APPENDIX E

AGENCY AND PUBLIC COMMENTS ON DRAFT P2TP/ RESPONSE TO COMMENTS

US Fish and Wildlife Technical Comments
Lake Okeechobee Watershed Construction Project
Phase II Technical Plan (Plan)

**Northern Everglades Initiative
Phase II Technical Plan - Draft Report Comments
SFWMD Comment Period Ending 13-Dec-07**

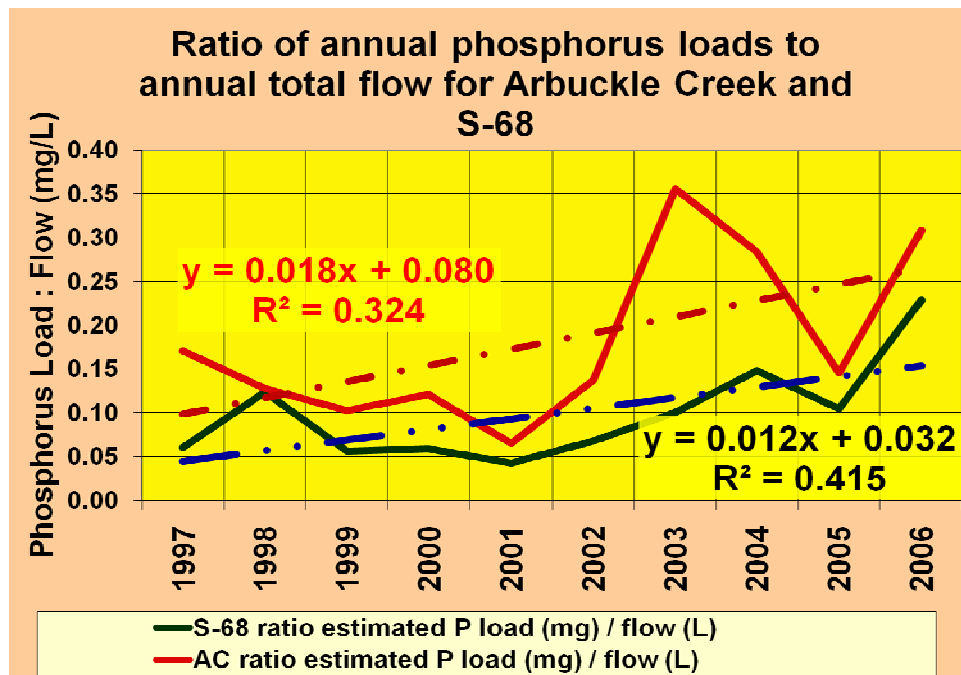
- A trend analysis of P dynamics in Lake's Istokpoga and Kissimmee should be conducted. P control measures from these lakes are based on average loads over the past 15 years, but we note that P concentrations have roughly doubled from these lakes over this time period (Fig. 1 shows recent Istokpoga trends). If the increasing trend continues, calculations based on the present average will underestimate future needs.

5-13 The same concerns discussed for changing P levels and future saturation on the Kissimmee Chain and River apply to Istokpoga (Fig. 1). Planning to use these lakes to treat P in the short term will cause more severe, and expensive, P problems in the long term. The Plan must explicitly develop strategies to prevent P saturation.

page 9-18 Section 9.2.3.3 line 607

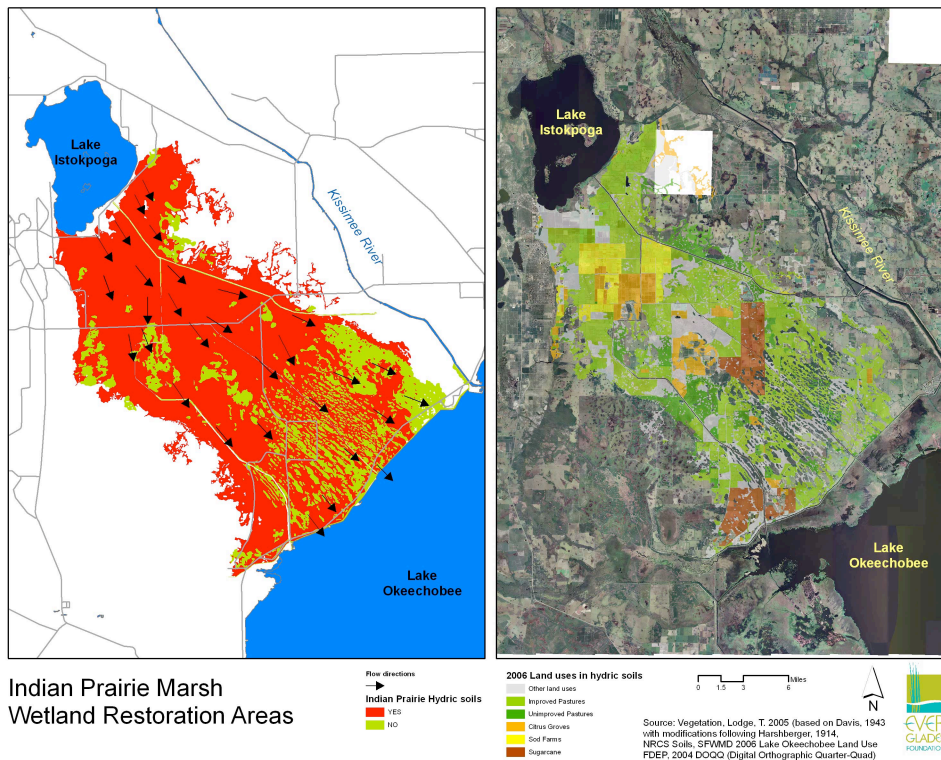
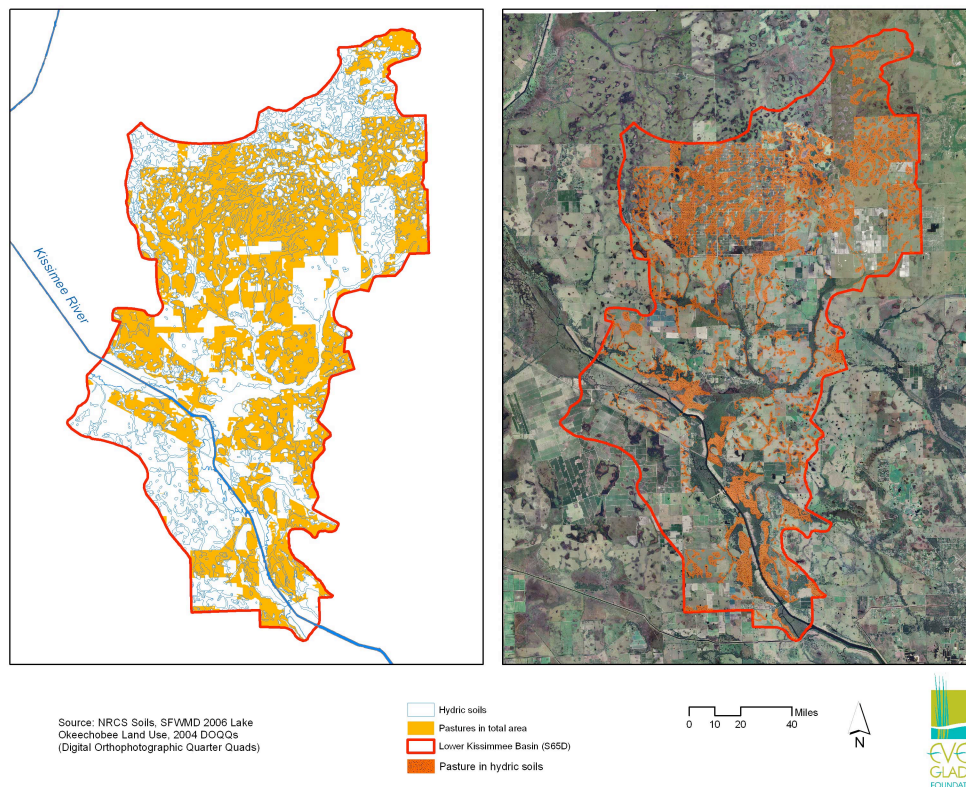
We are extremely pleased to see that Wetland Restoration is included in this plan. This will be an important step in improving the overall ecological function of the basin, rather than sacrificing the basin for the sole benefit of other areas. However, we would like to see an identification of other areas that could greatly improve overall basin ecological function. We suggest that the S-65D basin and the Lake Istokpoga basin are good candidates for restoration, as shown in the figures below.

Expansion of viable wetlands in the Indian Prairie marsh would greatly improve the ecological function of the basin and the Lake.

S-65D also has significant possibilities for wetland restoration, improving storage and ecological function.
